NRA presentation

NRA's updates since the January Mission

OTSUJI YAMAMOTO Ayako
Nuclear Regulation Authority JAPAN

Comprehensive Review Mission

1-2 Scheme to select radionuclides to be measured and evaluated

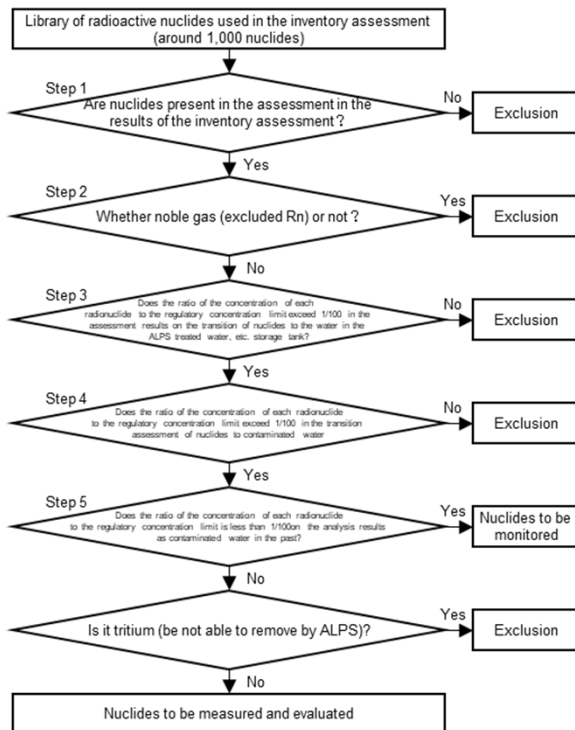
- TEPCO comprehensively includes fission products and activation products as radionuclides that may possibly exist in contaminated water. Also, the analysis codes used for the inventory assessment have already been validated by measures such as experiments. 【Step 1】

- For selecting radionuclides to be measured and evaluated effectively, the concentration of each radionuclide in contaminated water is evaluated step by step with the decay considered. Also, the transfer to contaminated water is evaluated using the analytical results whose reliabilities including analytical methods are validated. 【Step 1~4】

- The criteria to exclude radionuclides by 1/100 of the regulatory concentration limit or less are set with consideration given to the contributions to dose of the radionuclides excluded and the ones which move on to the next step. 【Step 3&4】

- Radionuclides excluded at step 5 are limited to those which concentrations in contaminated water have been clearly confirmed below 1/100 of the regulatory concentration limits in the analytical results. 【Step 5】

- Considering possible changes of the condition of contaminated water depending on the progress of the future decommissioning work, TEPCO periodically checks the validity of the selection of radionuclides to be measured and evaluated by continuously conducting measurements of contaminated water and, as necessary, re-assess the selection. 【Step 1~5】
